Product / Process Change Notification (PCN)

PCN #: PCN_UtRJ45LAN_20191031

Affected Series: WE-UtRJ45LAN

BEFORE CHANGE

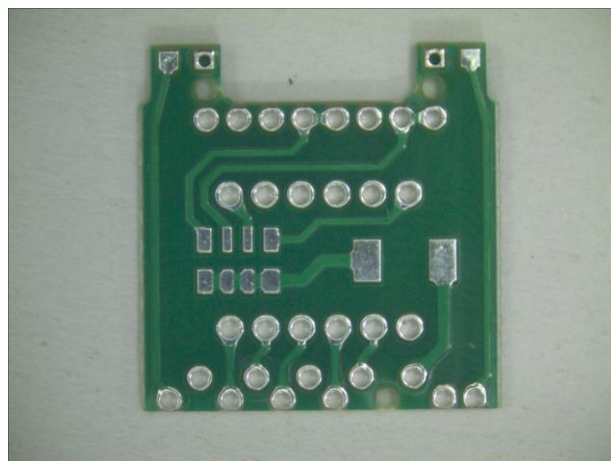
Due to an improvement of the production capability, Würth Elektronik will change the color of the PCB.

MATERIAL: FR4

AFTER CHANGE

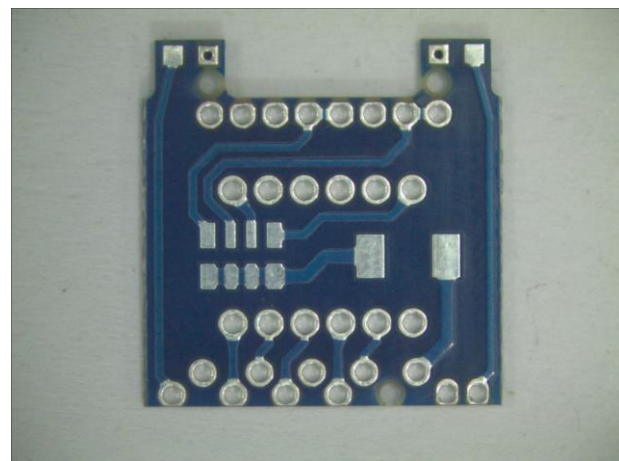
MATERIAL: FR4

The color helps to identify SMT or THR products, what is convenient for production.

There will be no change of the PCB layout!
